UNITED STATES
NUCLEAR REGULATORY COMMISSION
WASHINGTON, D. C. 20555

INDEPENDENT VERIFICATION OF THE OPERABILITY
OF REACTOR TRIP BREAKER SHUNT AND UNDER-VOLTAGE COILS

NS-EPR-2588
April 29, 1982

FIGURE 1

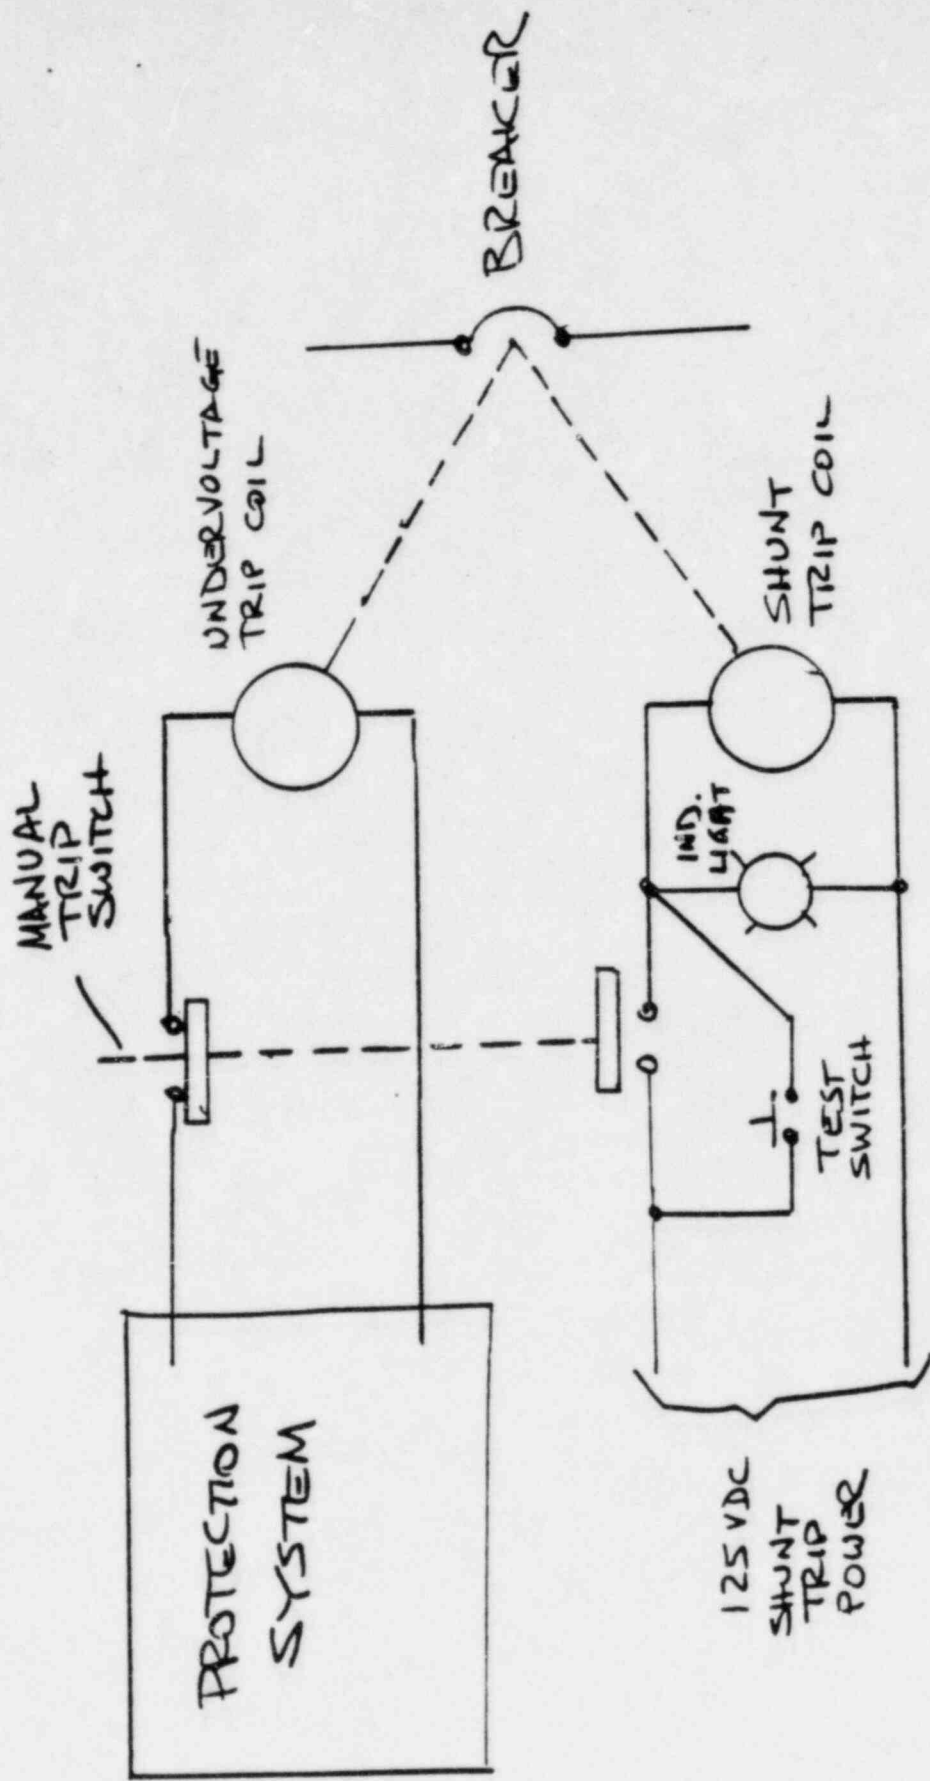
For discussion purposes, Fig. 1 provides our interpretation of this proposed modification. A typical procedure to independently verify the operability of the undervoltage and shunt trip features may be as follows:

The staff concludes that the above test includes sufficient steps to conduct the testing to verify independently the operability of the shunt and undervoltage coils of the manual reactor trip. Further the order of the procedures assures that the removal of power, to independently verify operability, is conducted in a sequence to assure that power is restored. The method proposed by TVA is a straightforward modification which accomplishes the desired function. Other schemes could likewise be used and with the same end result. Some utilities may prefer to utilize key locked test switches for improved administrative control or may prefer to use multi-position test switches with sequenced operations that use contact to remove power, instead of other alternatives, or use contacts to remove the indicating light from the circuit when not in test. In any event, the staff concludes that such simple and straightforward modifications to provide a test capability would not degrade the system.

The staff has not examined the layout of terminal block and connections with the test circuit shown in the figure to determine how it would interface with the existing design. However if the points of interconnections are reasonably accessible one might consider whether it is necessary to add test features in order to accomplish the objective of independent verification of operability of shunt and undervoltage coils. Recognizing that the staff has advocated built-in test capabilities, it is willing to listen to requests for specific exceptions. Since the testing in question would only be performed during plant shutdown this is a factor which limits the potential adverse effects, as contrasted to normal power operation. In the test sequence outlined, a test meter could readily perform the function of the "Indicating Light". Under controlled conditions a momentary electrical connection could duplicate the action of the test switch. The staff does not view this in the same light as those measures which require the use of jumpers to bypass safety actions that if not removed could render systems inoperable. In this case even if a jumper were used to energize the shunt-coil, the scram breaker could not be reset if the jumper were not removed. Therefore while the staff does not advocate alternatives to built-in test capabilities, this particular case is not one in which it would take the position that such alternatives would not be considered.

<u>ACTION</u>	<u>PURPOSE</u>
1. Reset reactor trip breaker.	Permit breaker test.
2. Remove Fuse for shunt coil power.	Permit independent verification of undervoltage coil operability.
3. Actuate "Manual Trip".	Confirm manual trip by undervoltage coil.
4. Replace Fuse for shunt coil power.	Permit shunt coil test.
5. Repeat Step 1.	Same as 1 above.
6. Actuate "Test Switch".	Confirm test trip by shunt coil. Confirms power restored to shunt coil circuit and operability of "Indicating Light".
7. Actuate "Manual Trip Switch".	"Indicating Light" confirms power is applied to shunt coil by "Manual Trip Switch".

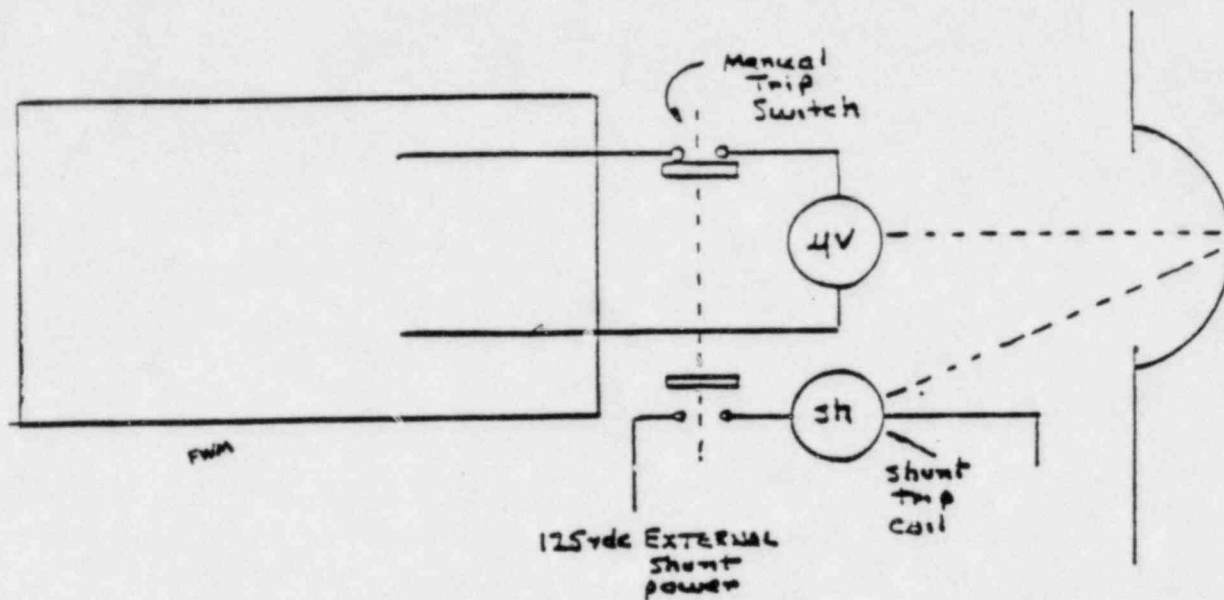
This design has been reviewed, accepted, and licensed many times. It should be noted that in the St. Lucie plant design, the protection system not only de-energizes a uv coil in the breaker but, at the same time, energizes a shunt coil in the breaker. The shunt coil causes the breaker to open in a manner identical to the undervoltage coil. Credit cannot be taken for shunt circuits since they require power to operate and violate GDC 23 which requires the system to fail safe on loss of power. Failure of shunt circuit power would prevent opening the breaker, not open it.
